Our Ref: BR/6096

Re: Interbridges, New Brighton Road, Emsworth (LPA ref. APP/24/01010)

Bellamy Roberts has been instructed by PNH Properties to prepare a further written response to further consultation comments received from the Highway Authority dated 23rd May 2025.

CLIENT PNH Properties		
PROJECT Interbridges Site, Emsworth		
TITLE New Brighton Road - Existing Junction Layout		
DRAWN BY IO	DESIGN BY -	CHECK BY MT
DATE 02/10/25	DRAWING No. 6096 / 012	
SCALE 1:250 @ A3	REV No.

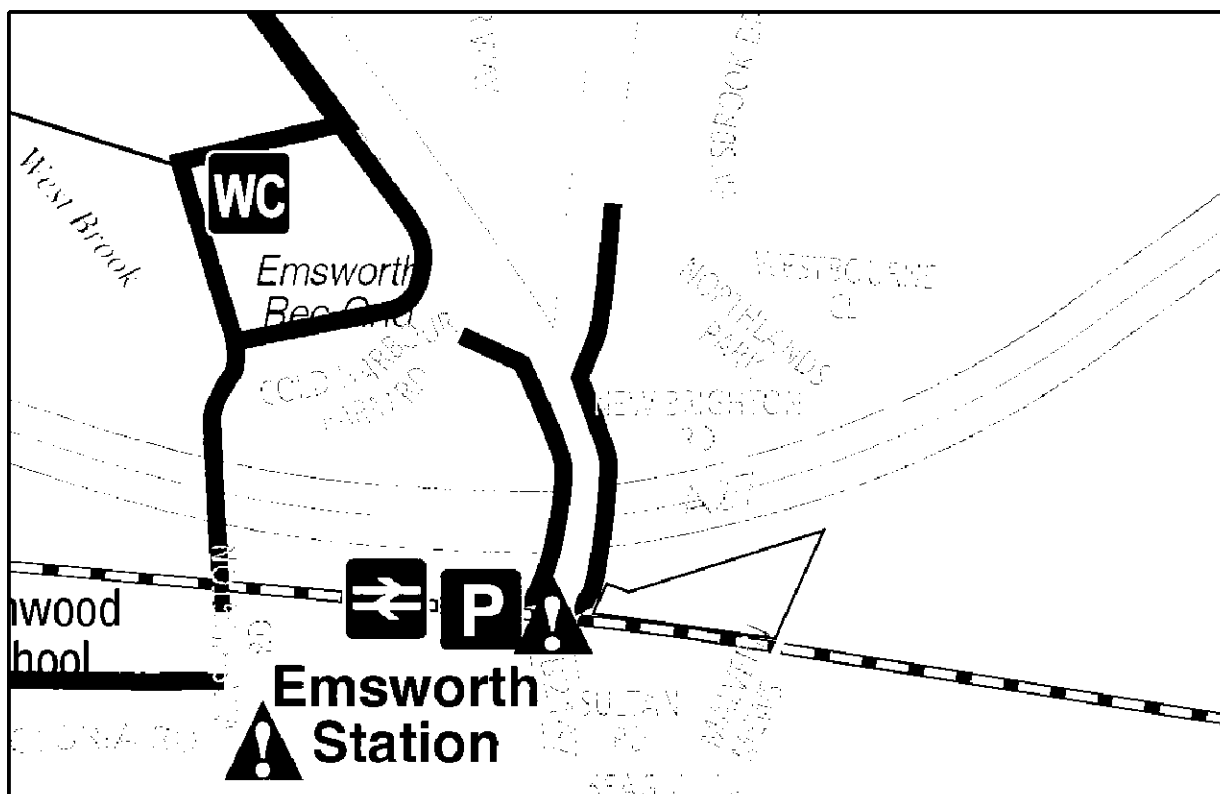
Whilst the existing junction accommodates both pedestrian and cycle movements, some deficiencies have been noted regarding pedestrian and cycle provision and are considered in the following paragraphs.

The existing junction layout is shown on the enclosed plan 6096/012. This shows the presence of a dropped kerb crossing on New Brighton Road, albeit this located approximately 20m from Horndean Road. Pedestrians travelling either north or south along the eastern side of Horndean Road would therefore need to deviate from the desire line in order to cross New Brighton Road.

With reference to Havant Borough Council's cycle map and guide, Horndean Road and New Brighton Road are part of the signed cycle network and a shared footway/cycle way is located in this area. An extract from the cycle map is provided at Figure 1 and shows the location of these facilities in relation to the application site, which is shaded red.

To address the deficiencies identified for pedestrian and cyclists, an improvement scheme has been prepared showing a continuous footway crossing for pedestrians and a means for cyclists to access the shared footway/cycleway when travelling south along Horndean Road. This is shown on the enclosed plan 6096/013.

DRAWN BY	DESIGN BY	CHK BY
MB	-	MT
DATE	DRAWING No.	REV No.
23/05/24	6096 / 001	H
SCALE		
1:250 @ A3

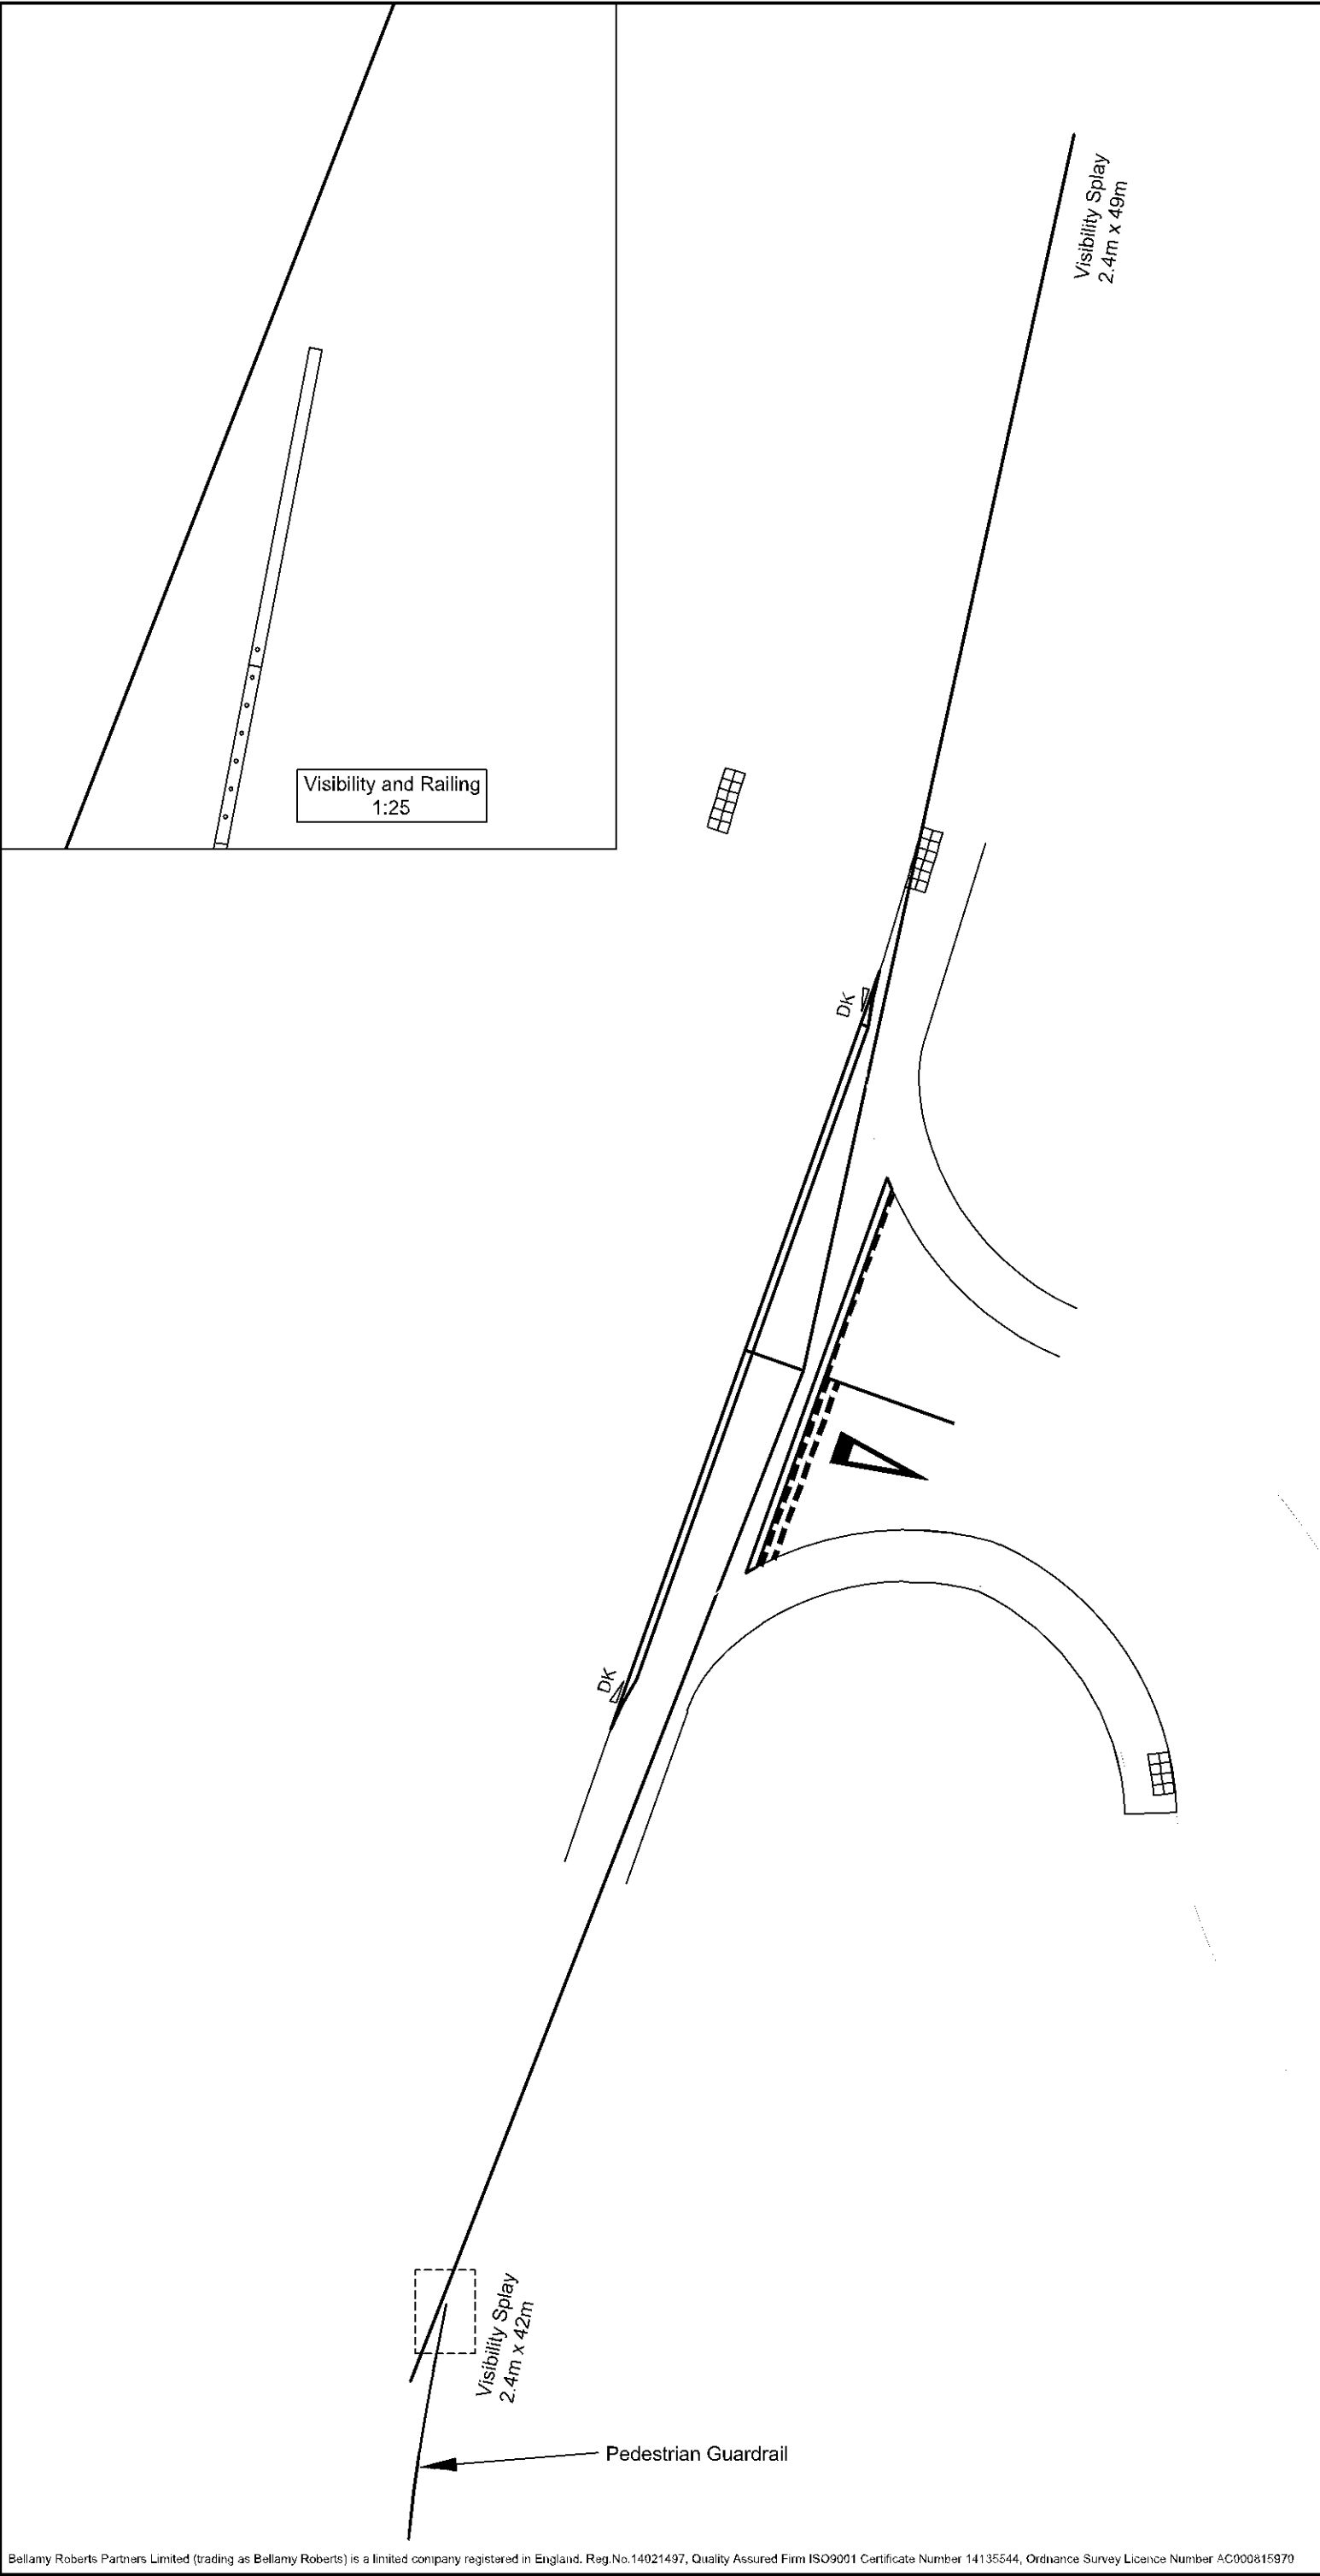
Visibility at the site access will not be obstructed by the guard rail to the south. For the purposes of demonstrating a clear gap between the visibility splay and guard rail on the visibility splay drawing, the splay has been plotted at an offset of 500m from the nearside carriageway edge. However, an offset of 310mm is sufficient to avoid any obstruction from the guard rail.

Whilst additional information has been provided on several drawings it is noted that the footprint of the site access arrangement is not consistent across the drawing pack. A consistent GA should be provided for consideration.

The Highway Authority consider that the priority arrangement shown on drawing 6090/001 Rev F would take pedestrians away from the desire line and is therefore not supported. The priority give way arrangement shown also only gives priority to those vehicles exiting the site which is not considered appropriate. Vehicles waiting at the give way line would also sit across the priority arrangement if larger than a family car. A crossing should therefore be maintained on the desire line.

The continuous footway crossing at the proposed site access has been amended following discussions with the Highway Authority and the amended layout is enclosed. This now reflects the guidance contained within Technical Guidance Note 10 (TG10) and ensures pedestrians are not taken away from the desire line along North Street.

The drawing pack has been updated to show a consistent general arrangement and the updated plans are enclosed.

A photograph from the location of the proposed site access, looking south is provided below:

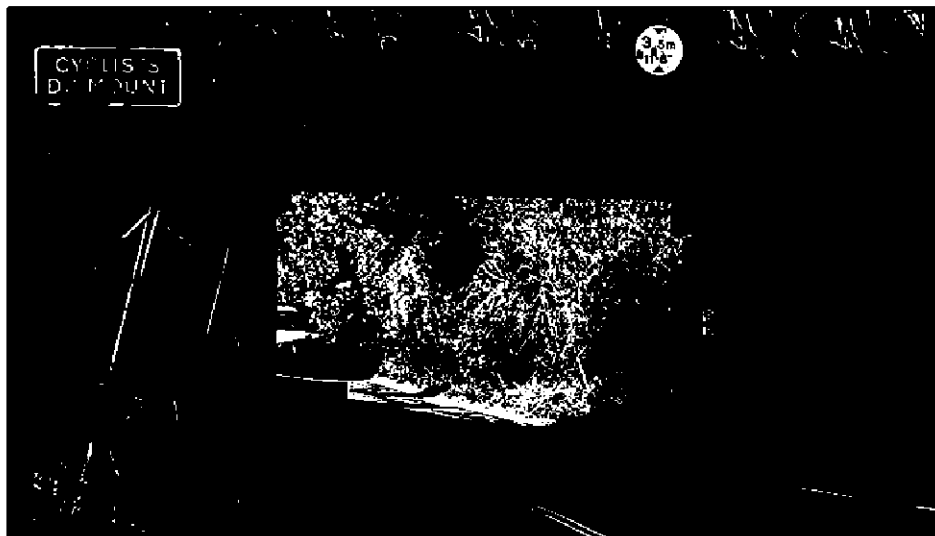
During the meeting with the Highway Authority on 5th August, the Authority stated that any offset greater than the 300mm stated in TG3 would require a departure from standard. The TG3 document states that non-compliance with a mandatory requirement, defined as being associated with the words "shall" or "shall not", will require a departure. The relevant text within TG3 states as follows:

This passage does not contain the words "shall" or shall not" therefore I would question whether this does in fact require a departure.

In any event, such a departure request is considered wholly unnecessary given the additional offset is 10mm only and of no material impact when considered over the length of the visibility splay, it is purely to demonstrate no obstruction of the visibility splay.

Nevertheless and as requested by HCC, the relevant departure from standard form has been completed and this is enclosed.

Proposed Crossing Horizontal Proposed Lighting Level

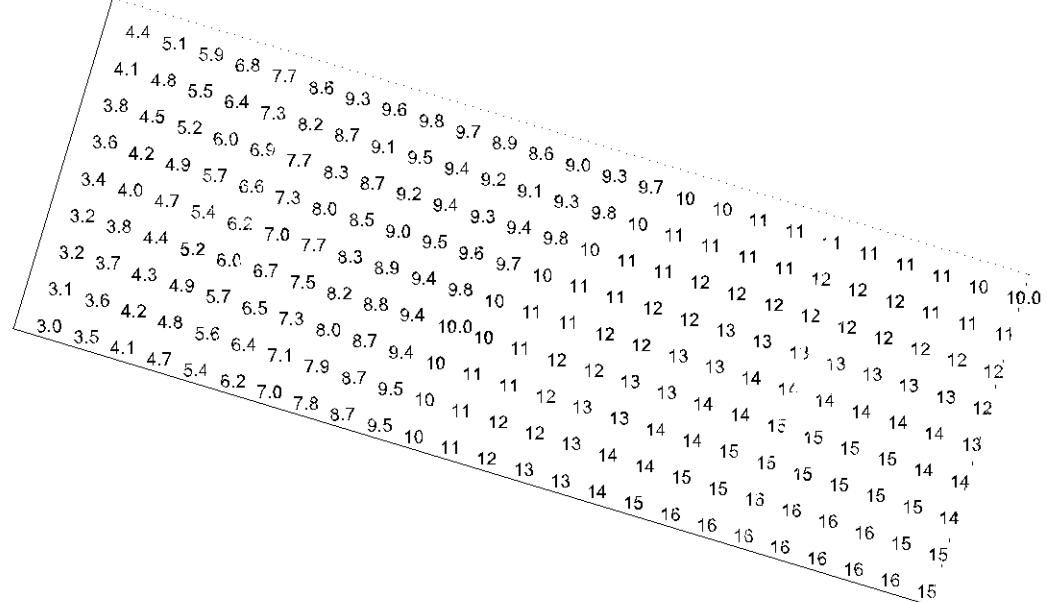
The Stage 1 RSA of the proposed relocated crossing point identified a problem at the western crossing point, stating that "pedestrians crossing from a dark area could lead to sudden braking and rear end shunt collisions, or vehicle to pedestrian collisions."

In addition to this, the Highway Authority also requested that consideration should also be given to the effects of glare on drivers passing under the A27 bridge deck and its impact on visibility at the pedestrian crossing.

The street lighting assessment has determined that additional lighting provision is required along North Street, under the A27. Two new lighting columns are proposed, both on the western side of North Street. An existing lighting column on the eastern side of North Street will be relocated to accommodate the proposed site access. It is understood that the additional street lighting has been agreed with the relevant officers at HCC.
